29 NEW END NW3 1JD

MINOR MATERIAL AMENDMENT APPLICATION 25 AUGUST 2017

MINOR MATERIAL AMENDMENTS

2.1 LOWER GROUND FLOOR PLAN AMENDMENTS

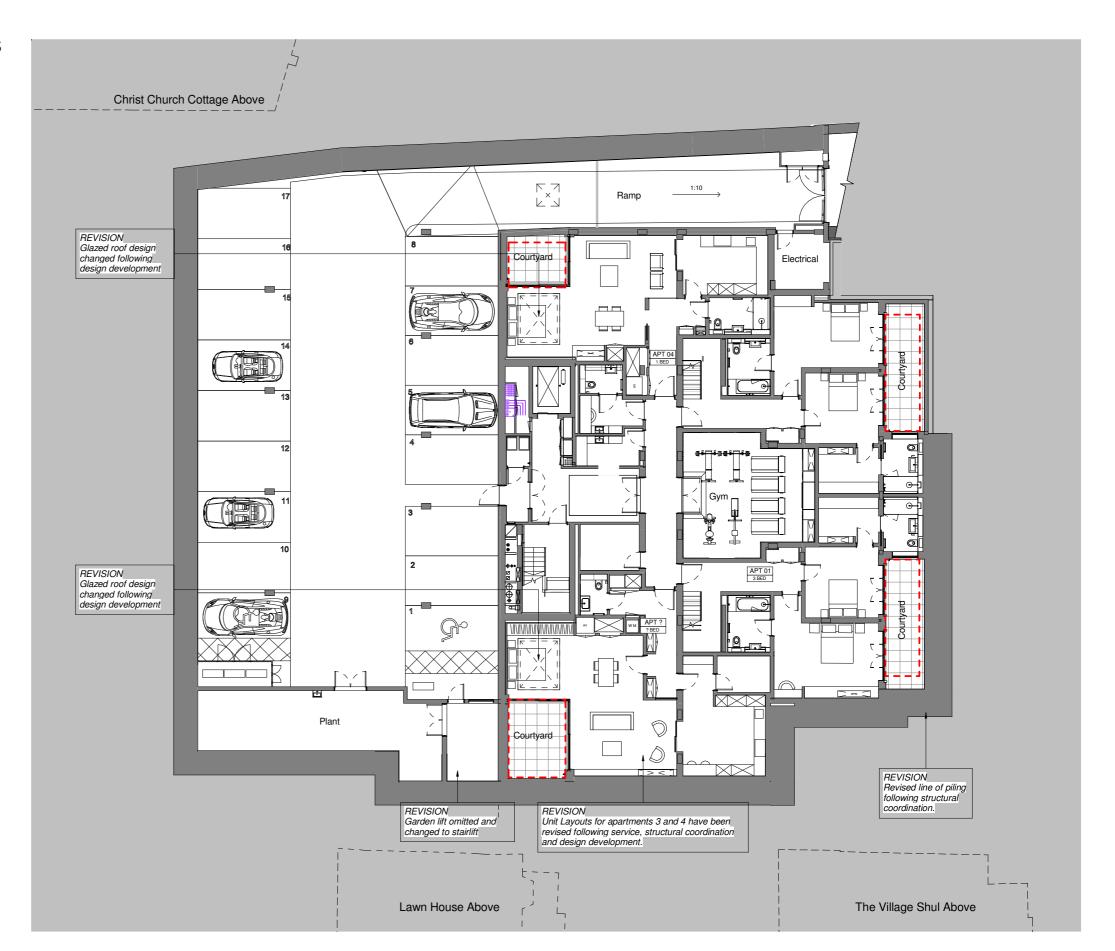
- 1. Services. Following services coordination there have been alterations to the plant enclosure, cycle store and refuse area. These do not impact on the external facade.
- 2. Revised line of piling.
- 3. Unit layouts for apartments 1, 2, 3 and 4 have been revised following service and structural coordination and design development. The changes do not alter the external reading of the facade.
- 4. Garden lift omitted and changed to stairlift.
- 5. Changes to glazed extension to apartments 3 and 4.

2.2 GROUND FLOOR PLAN AMENDMENTS

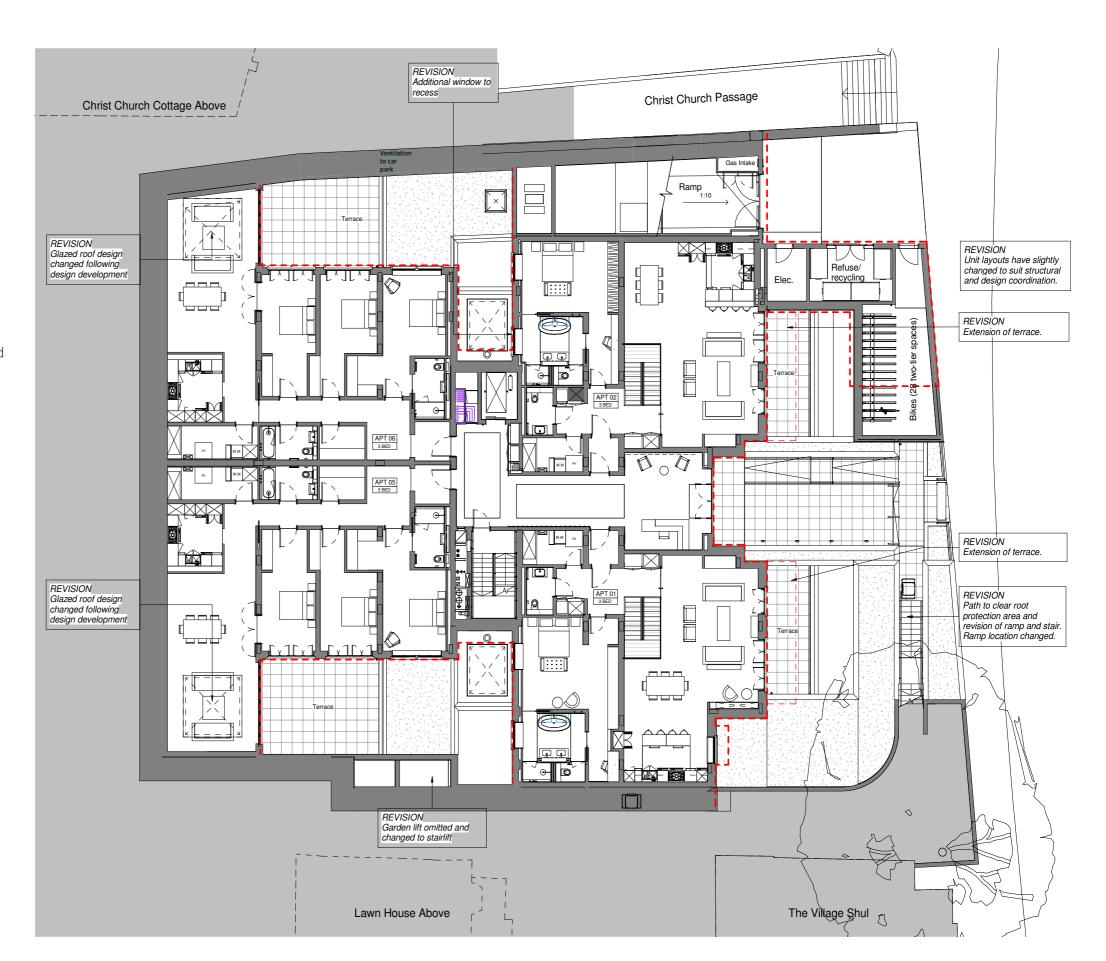
- 1. Additional window added into recess.
- 2. Revised line of piling.
- 3. Garden lift omitted and changed to stairlift.
- 4. Path to clear root protection area and revision of ramp and stair, location changed.
- 5. Extension of terrace, to Apartments 1 & 2.
- 6. Unit layouts for apartments 1, 2, 5 and 6 have been revised following service and structural coordination and design development.
- 7. Changes to glazed extension for units 5 & 6.

2.3 FIRST FLOOR PLAN AMENDMENTS

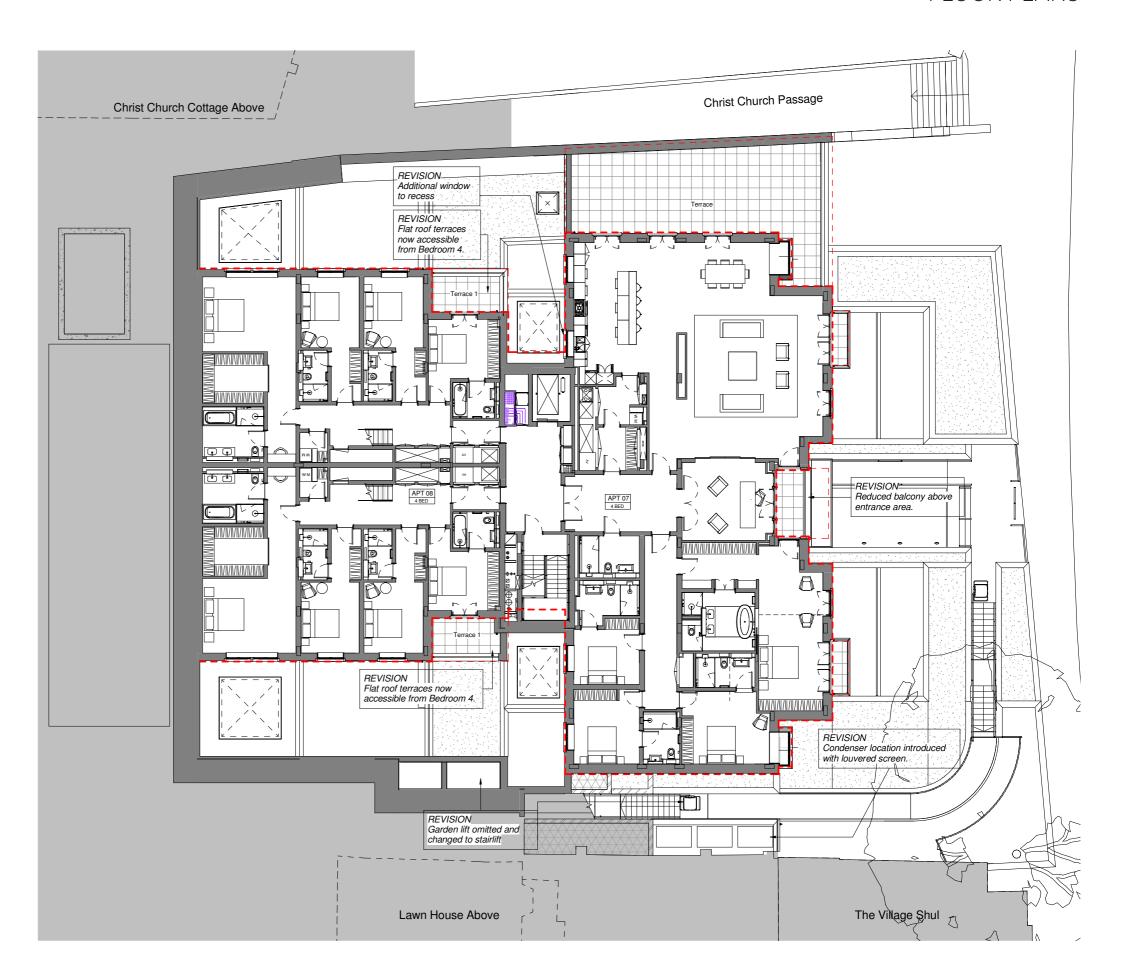
- 1. Additional window added into recess.
- 2. Flat roof terraces now accessible from Bedroom 4 in apartment 8 and 9.
- 3. Garden lift omitted and changed to stairlift
- 4. Revision to balcony above entrance area.
- 5. 5. Unit layouts for apartments 7, 8 and 9 have been revised following service and structural coordination and design development. The changes do not alter the external reading of the facade.
- 6. Addition of condenser units (air conditioning) along Garden Path behind a louvred screen.

2.4 SECOND FLOOR PLAN AMENDMENTS

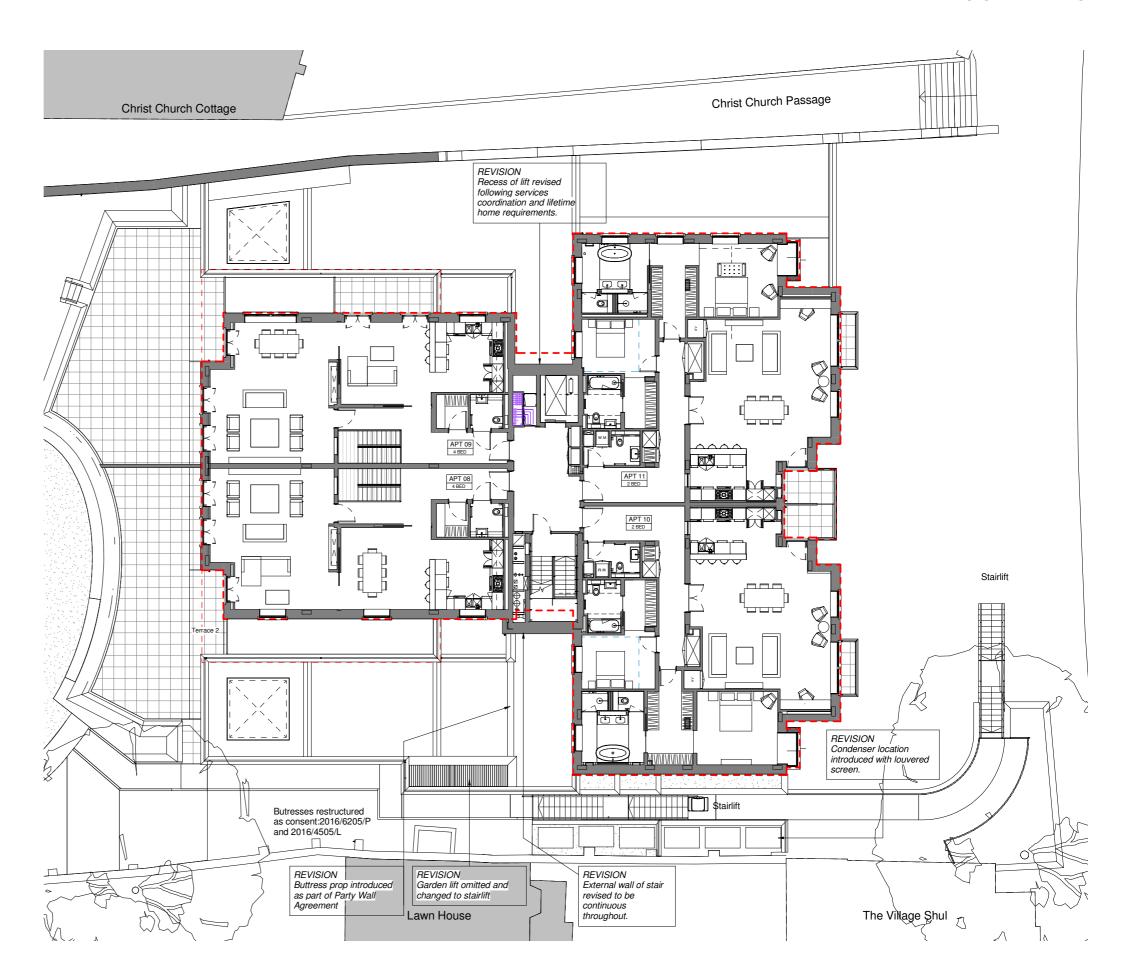
- 1. Recess of lift revised.
- 2. External wall of stair revised.
- 3. Garden lift omitted and changed to stairlift.
- 4. Unit layouts for apartments 8, 9, 10 and 11 have been revised following service and structural coordination and design development. Minor alterations to window locations to coordinate plan changes.
- 5. 5. Addition of condenser units (air conditioning) along Garden Path behind a louvred screen.
- 6. Buttress prop introduced as part of Party Wall Agreement.

2.5 THIRD FLOOR PLAN AMENDMENTS

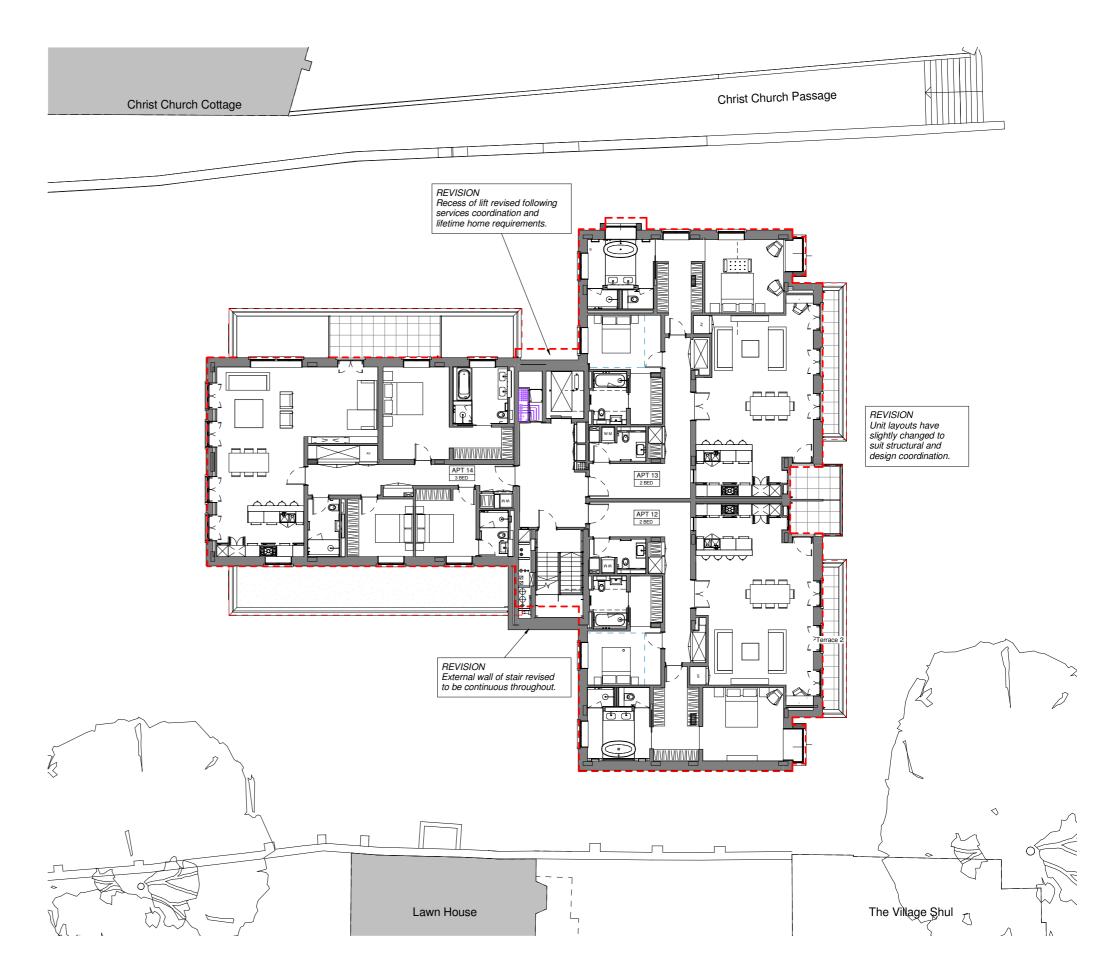
- 1. Unit layouts for apartments 12, 13 and 14 have been revised following service and structural coordination and design development. Minor alterations to window locations to coordinate plan changes.
- 2. Recess of lift revised.
- 3. External wall of stair revised.

2.6 FOURTH FLOOR PLAN AMENDMENTS

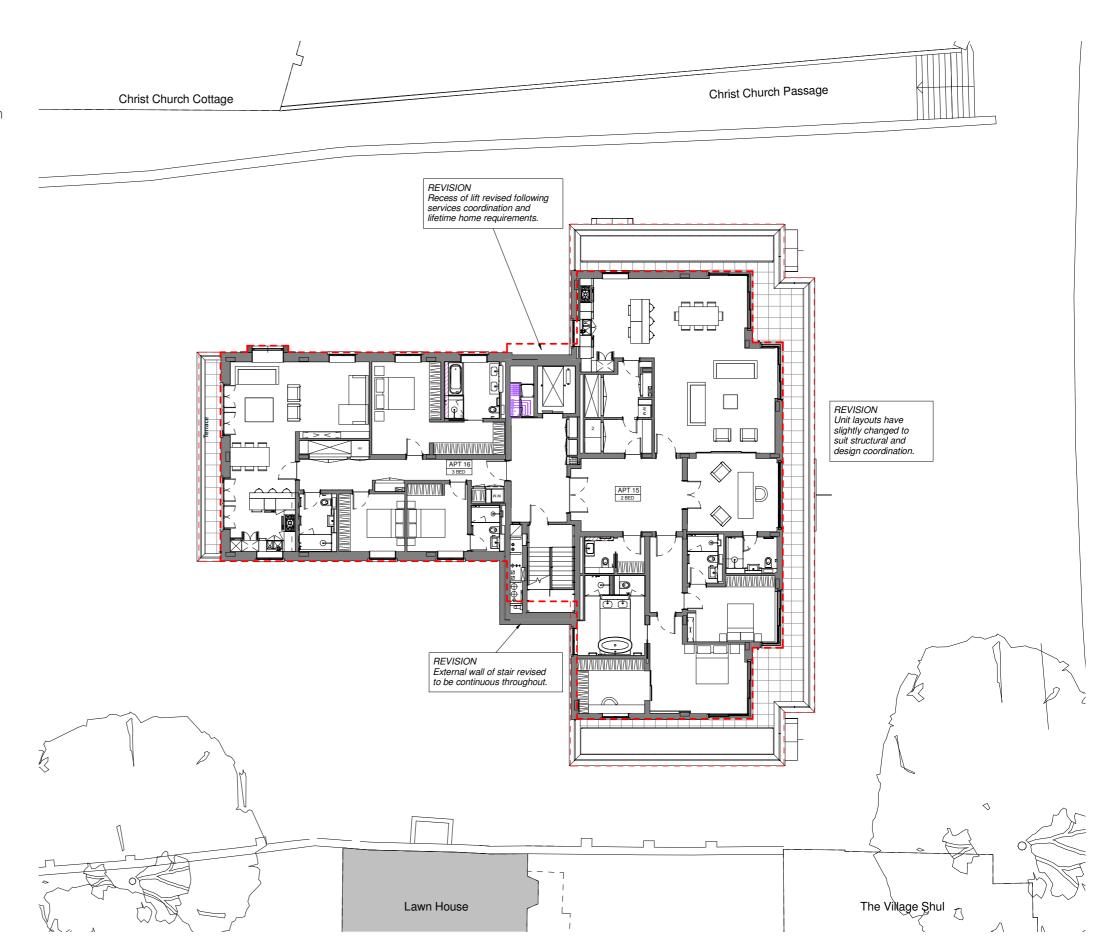
- 1. Unit layouts for apartments 15 and 16 have been revised following service and structural coordination and design development. Minor alterations to window locations to coordinate plan changes.
- 2. Recess of lift revised.
- 3. External wall of stair revised.

2.7 FIFTH FLOOR PLAN AMENDMENTS

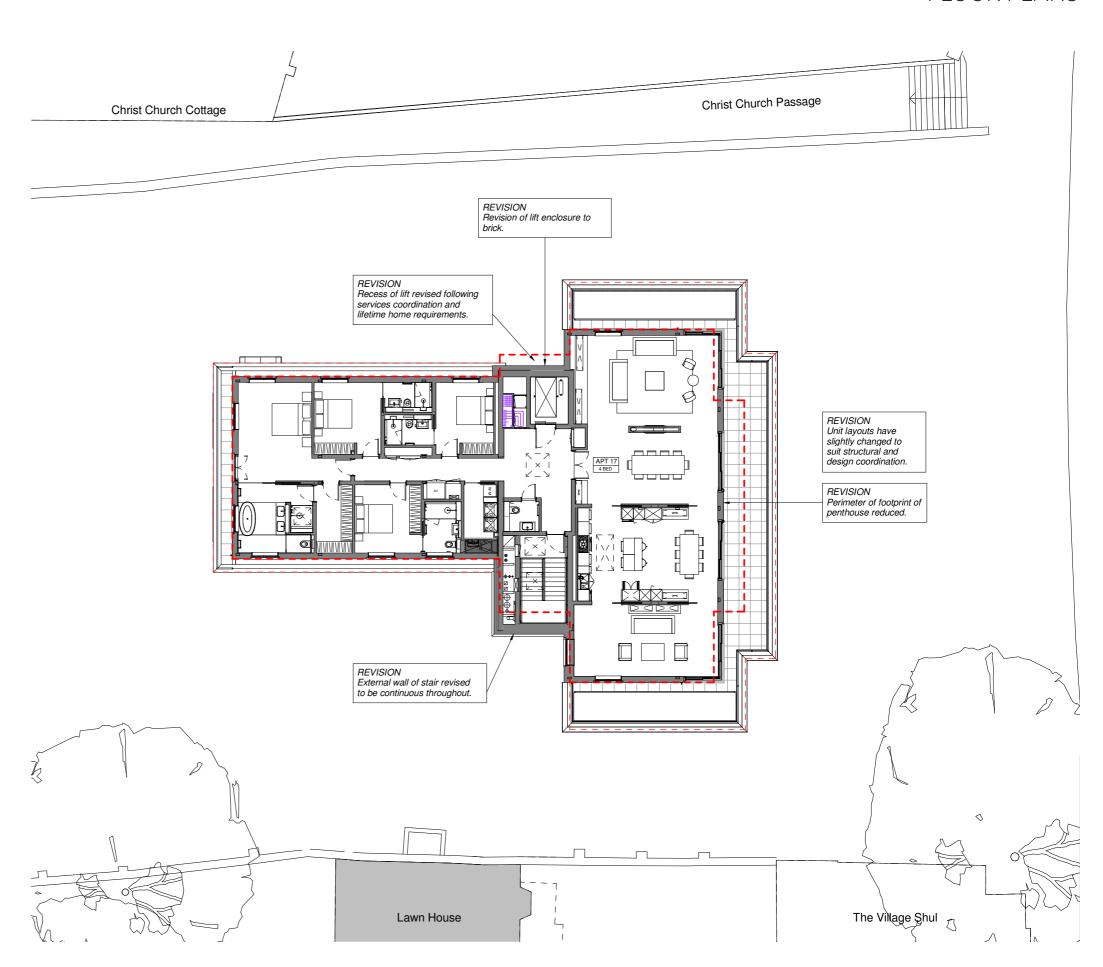
- Unit layouts for apartment 17 have been revised following service and structural coordination and design development. Minor alterations to window locations to coordinate plan changes.
- 1. Recess of lift revised.
- 2. External wall of stair revised.
- 3. Front facade recessed to increase terrace area.
- 4. Minor Revision of lift enclosure to brick.

2.8 ROOF PLAN AMENDMENTS

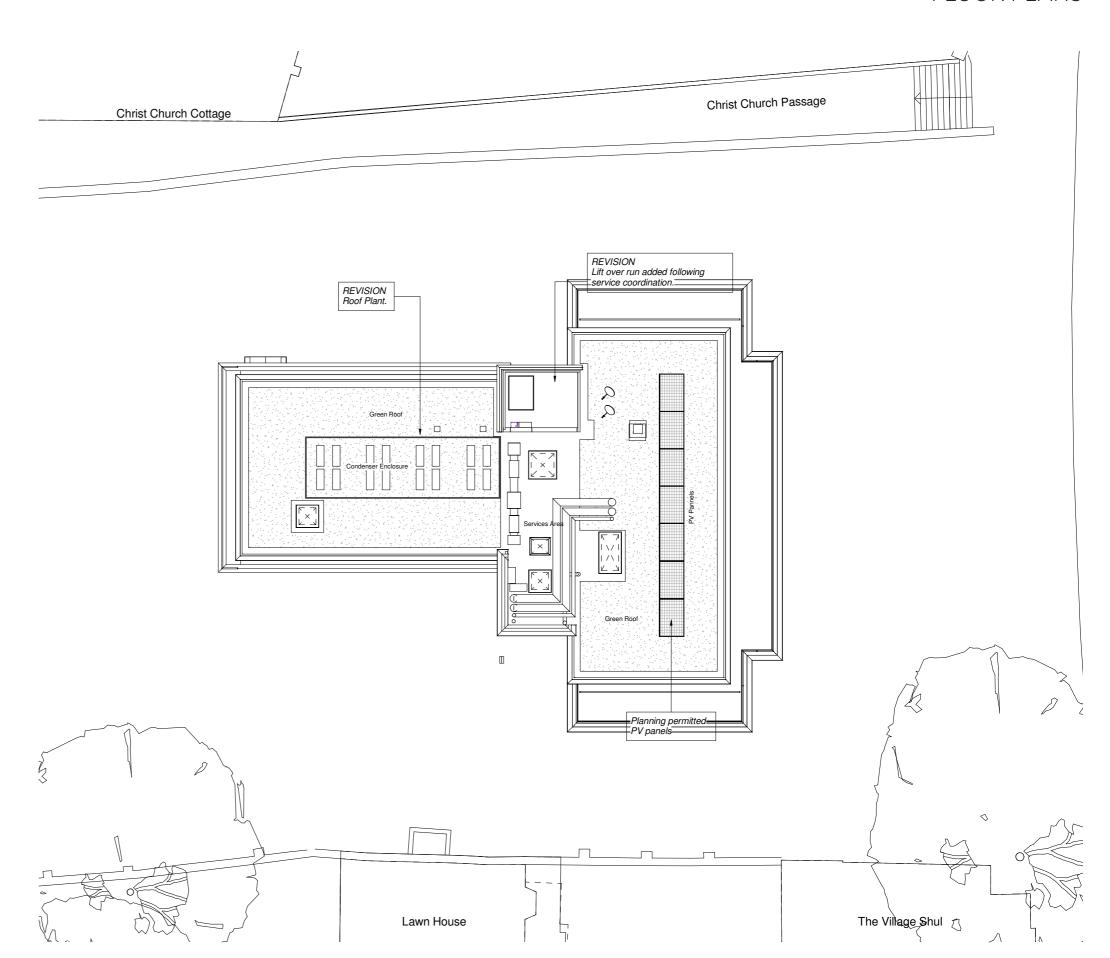
- 1. Lift over run added.
- 2. Roof plant enclosure enlarged and relocated following services coordination.
- 3. Roof plants added due to services development.
